# Springbank Off-stream Reservoir Project

Response to  
Agency Conformity  
Review of  
Round 1 Part 3,  
dated August 21, 2019

November 2019

**Figure 1-1 Flood Frequency Distributions with Climate Change Projections to 2050**

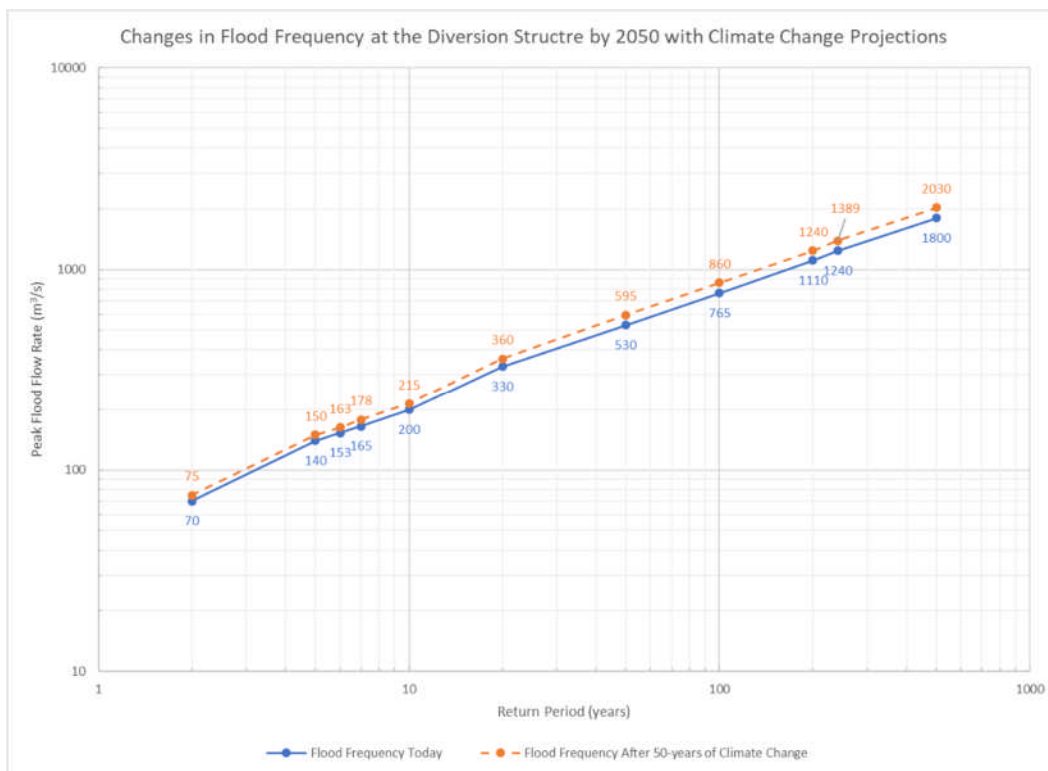
- a) Provide a new flood frequency analysis given the potential increase in frequency and severity of floods.**
- b) Provide an assessment of effects of the environment on the Project should a flood larger than the design flood occur and should flooding occur more frequently due to climate change, and associated potential effects to VCs.**

8. Step 1 to step 6 were then executed using the climate affected IDF rainfall data to produce a flood frequency distribution that considers climate change projections. The results are provided in Table 1-1 and Figure 1-1.

The flood frequency analysis results suggest that the operational flow threshold of 160 m<sup>3</sup>/s, which has an associated return period of approximately 1:7 years (i.e., 165 m<sup>3</sup>/s in the second column of Table 1-1) may have an associated return period of approximately 1:6 years under climate change projections (i.e., 163 m<sup>3</sup>/s in the third column of Table 1-1). The predictions indicate the severity of floods will be higher when climate change is considered (i.e., the flows with climate change in the third column for each specific flood return period in Table 1-1 is larger than the flow in the second column). As flood frequencies increase, there is a potential for the Project to be operated more frequently due to climate change effects.

Figure 15-1

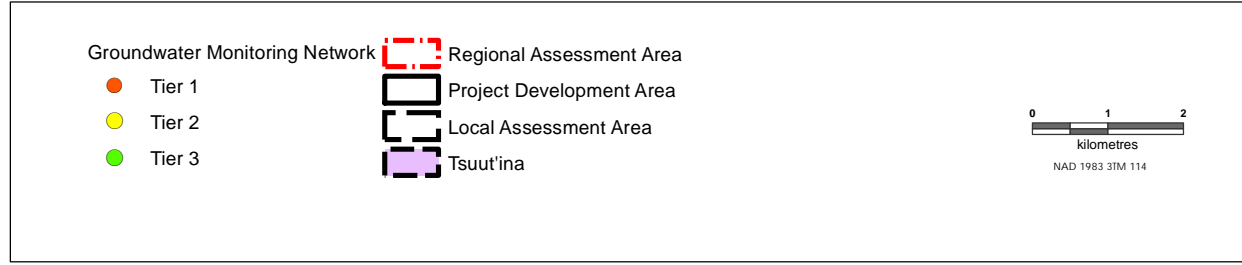
In Alberta Transportation's response to IR3-15, Alberta Transportation provides a draft groundwater monitoring plan. However, no specific discussion regarding the potential for the use of dedicated monitoring wells for groundwater head monitoring is included. As noted in the information request, the EIS only discusses the use of domestic water wells in follow-up and monitoring. The purpose of the follow-up program is to validate the results of hydrogeological modelling and domestic wells on their own are of limited value to evaluate water level predictions. The use of dedicated monitoring wells to allow groundwater head monitoring for both dry operations and flood/post-flood response should be considered.

**Additionally, the draft groundwater monitoring plan indicates that all monitoring wells to be included in the plan have been or, in the case of proposed wells, will be developed following completion. This does not provide clarity on whether any current monitoring wells will be maintained for use in follow-up and monitoring.**

The proposed monitoring network is presented in Figure 15-1 (adapted from the Groundwater Monitoring Plan). A total of 11 Project wells will be decommissioned, nine Tier 2 wells will be decommissioned and replaced, and 12 Tier 2 wells will be retained. The monitoring wells that are planned to be decommissioned and replaced will be replaced as close as possible to the original location but outside the inundation area or construction footprint. In addition to the Tier 2 wells that will be retained or replaced, three new monitoring well locations will be established around the perimeter of the PDA to improve the spatial distribution of the monitoring network.

**Figure 17-1 Calibrated Hydraulic Conductivity Through the Local Assessment Area**

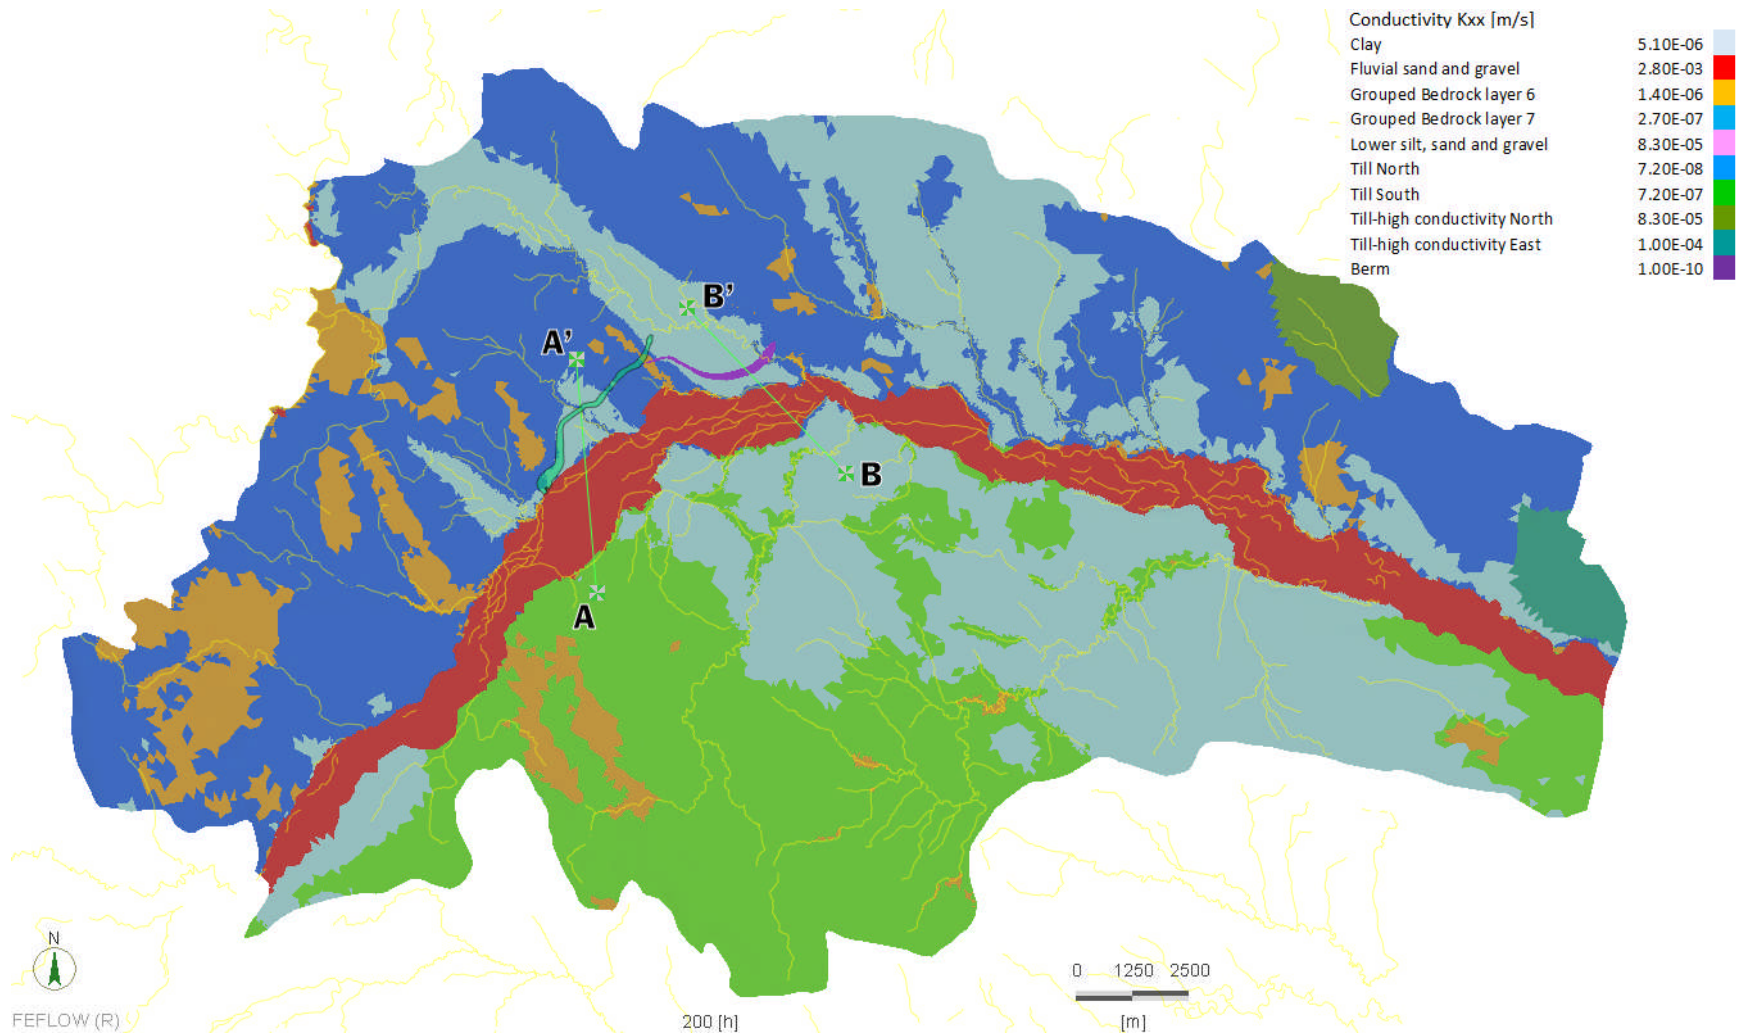
- **Provide maps and cross-sections of final calibrated hydraulic conductivities values, and the three zones of calibrated bedrock hydraulic conductivity**

- Figure 17-1 and cross sections (Figure 17-2 and Figure 17-3) present the calibrated hydraulic conductivity through the local assessment area (LAA). Two zones of calibrated bedrock hydraulic conductivity are used in the revised numerical model presented in the TDR Update. The use of two model layers is considered appropriate to represent an upper layer of the bedrock (Layer 6) which is considered to have more open fractures (i.e., higher permeability) compared to the lower bedrock (Layer 7). The calibrated hydraulic conductivities for the two bedrock units support this interpretation.

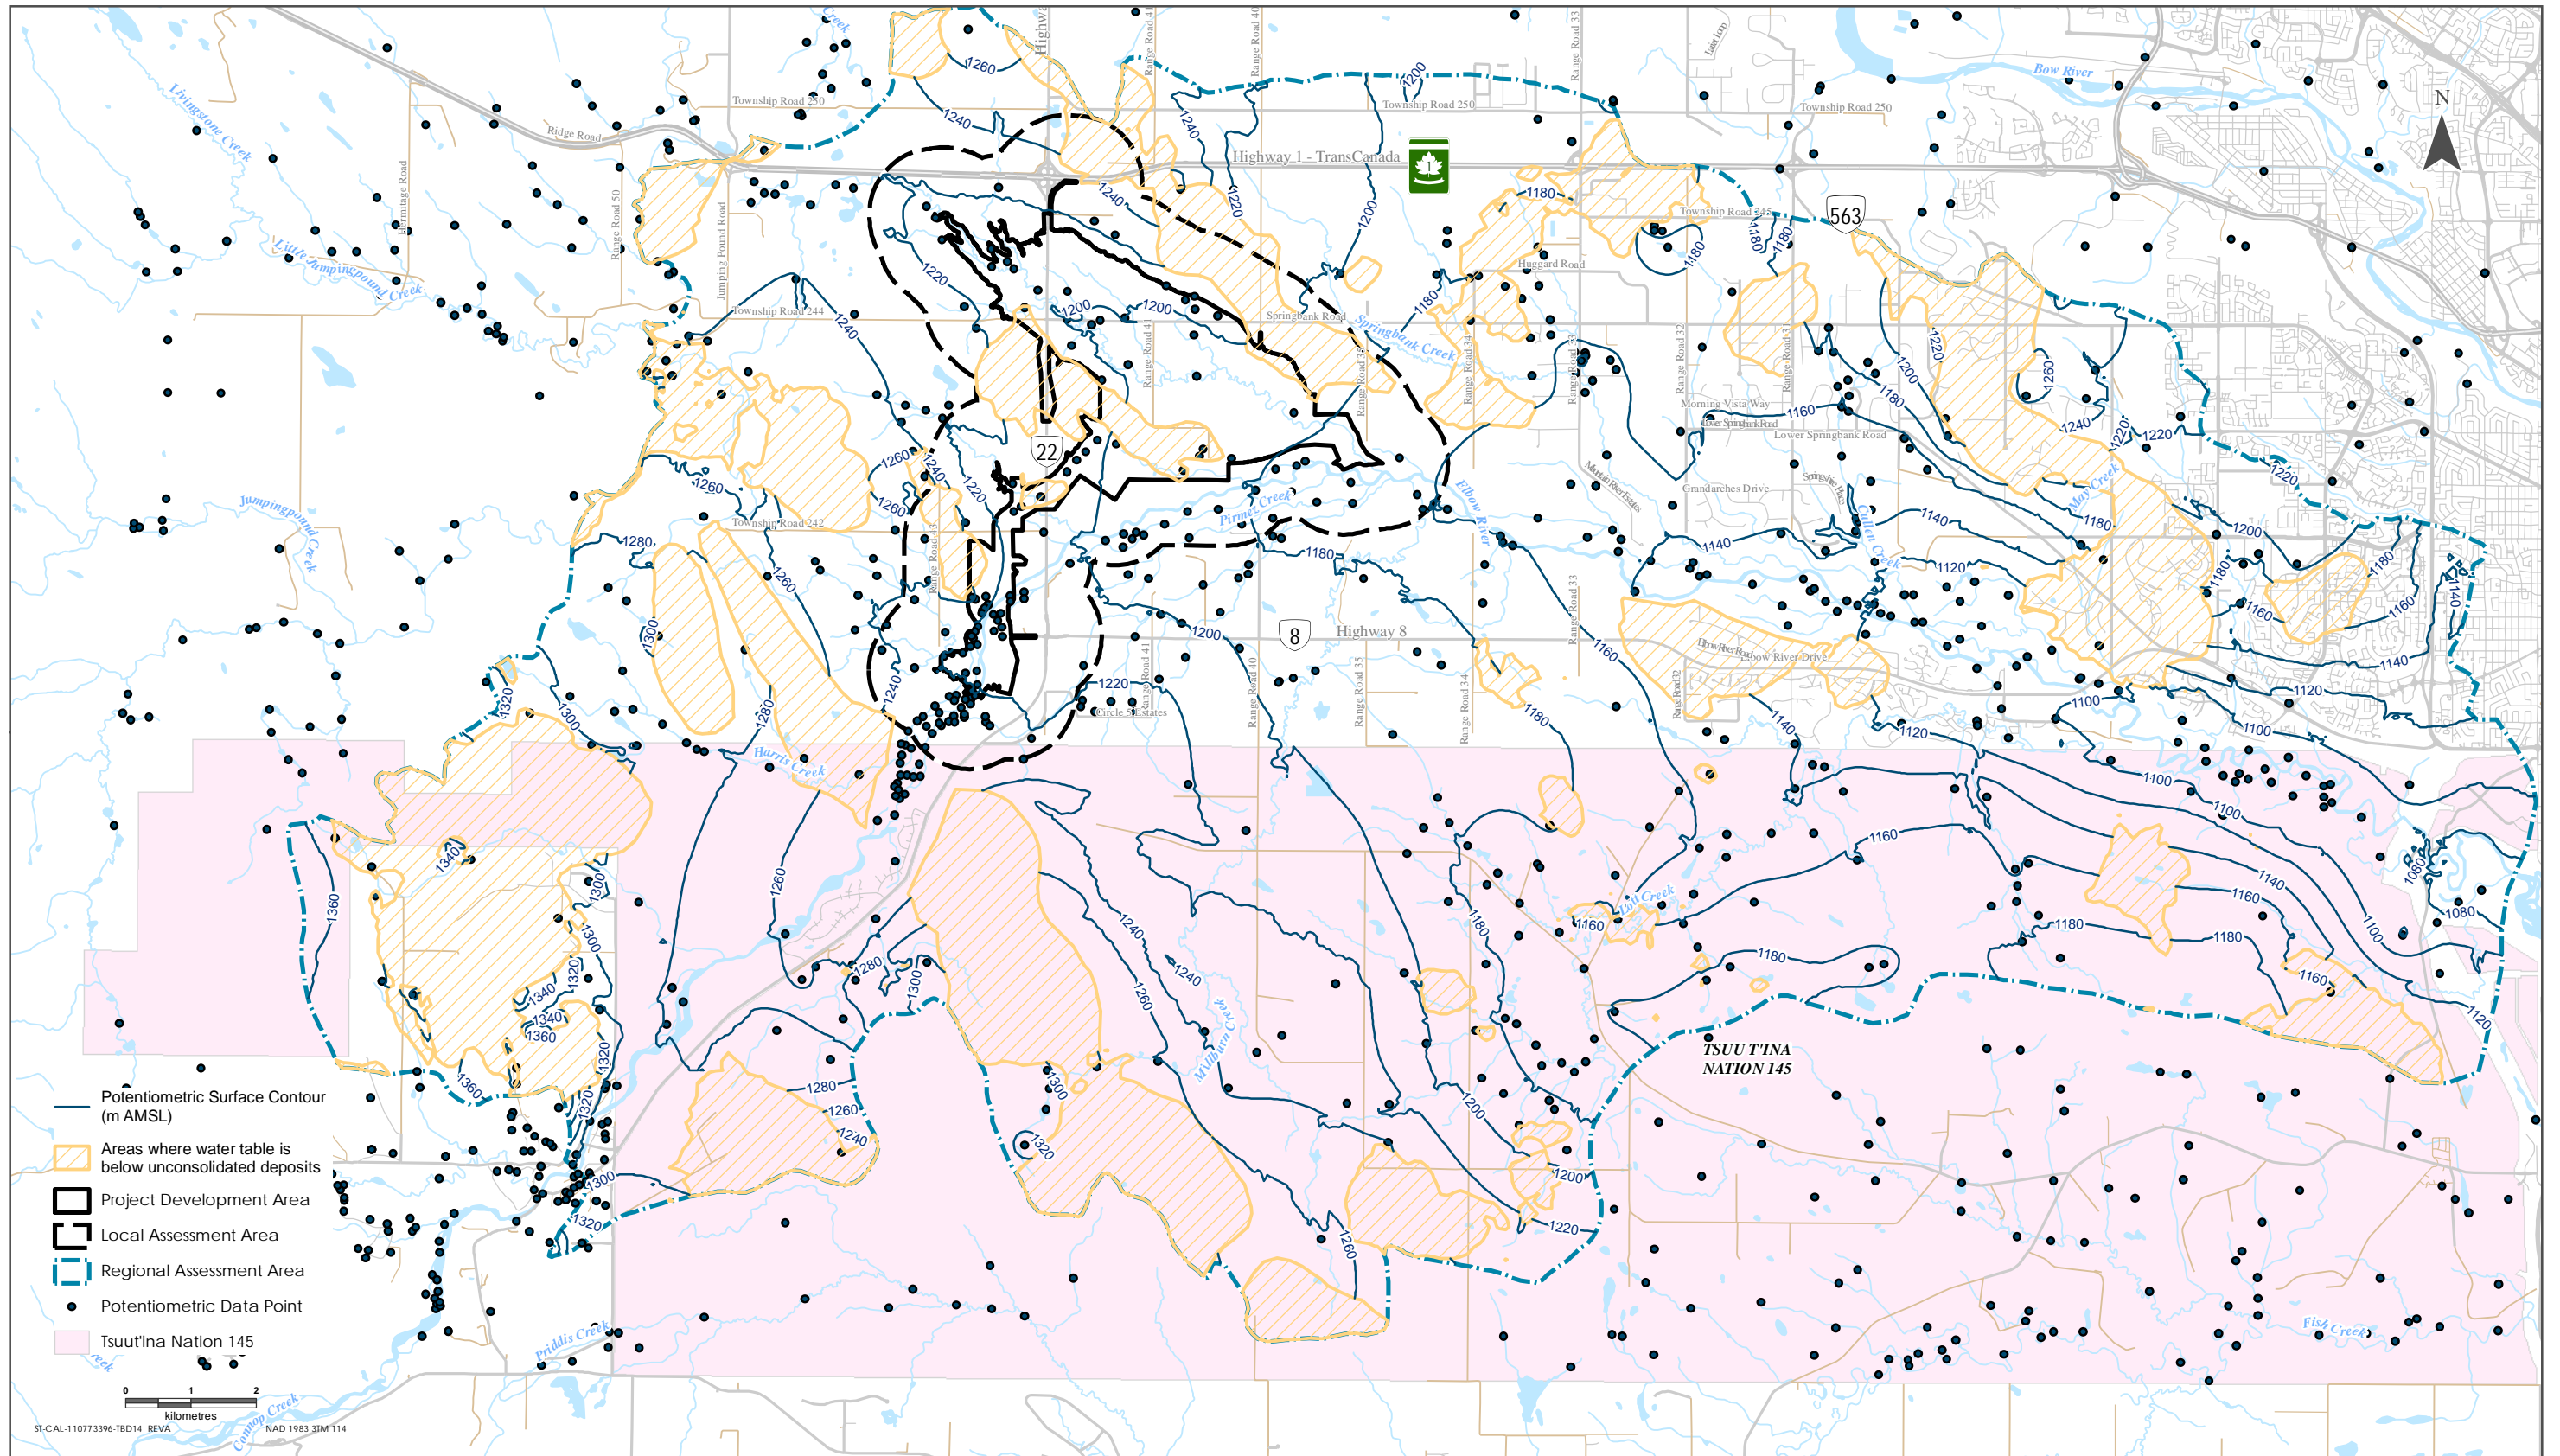
In IR3-18 b), the Agency required Alberta Transportation to identify all water level measurement locations used to map the potentiometric surface of unconsolidated deposits and clearly identify areas where the water table is below the unconsolidated deposits. It appears that a response to this IR is not provided.

Figure 18-1 identifies areas where the water table is below the unconsolidated deposits. The potentiometric contours have been removed from unsaturated areas of the unconsolidated deposits. The graphical representation of this information is not a concern for the new model.
